## Product Change Notice (PCN)

PCN Number: **PCN-0456169R-01**

Product(s) Affected: **PJ-031CH**

PREVIOUS CUI DEVICES DETAIL / IMAGE	NEW CUI DEVICES DETAIL / IMAGE

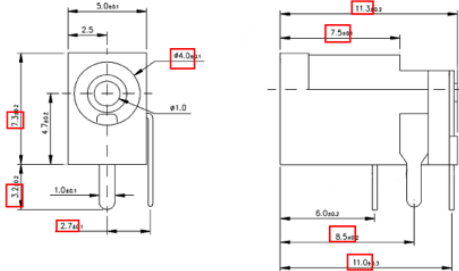
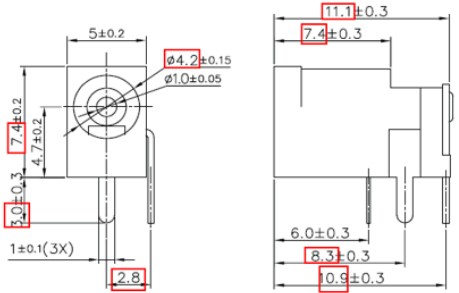
Description of Change: **Product re-engineered for improved manufacturability and production yield. See image below for product changes. Cosmetic differences may be visible and not affect the form fit and function of the product.**

PREVIOUS CUI DEVICES DETAIL / IMAGE			NEW CUI DEVICES DETAIL / IMAGE		
DESCRIPTION	MATERIAL	PLATING/COLOR	DESCRIPTION	MATERIAL	PLATING/COLOR
center pin	brass	silver	center pin	brass	CuSn
terminal 1	brass t=0.50	silver	terminal 1	brass t=0.40	silver
terminal 2	MM alloy t=0.20	silver	terminal 2	stainless steel t=0.20	silver
terminal 3	brass t=0.50	silver	terminal 3	brass t=0.40	silver
housing	PA10T (UL94V-0)	black	housing	PA10T (UL94V-0)	black

<p><b>MATING PLUG</b> Jack Insertion Depth: 7.0 mm</p>	 <p><b>MATING PLUG</b> Jack Insertion Depth: 6.2 mm</p>
--	---
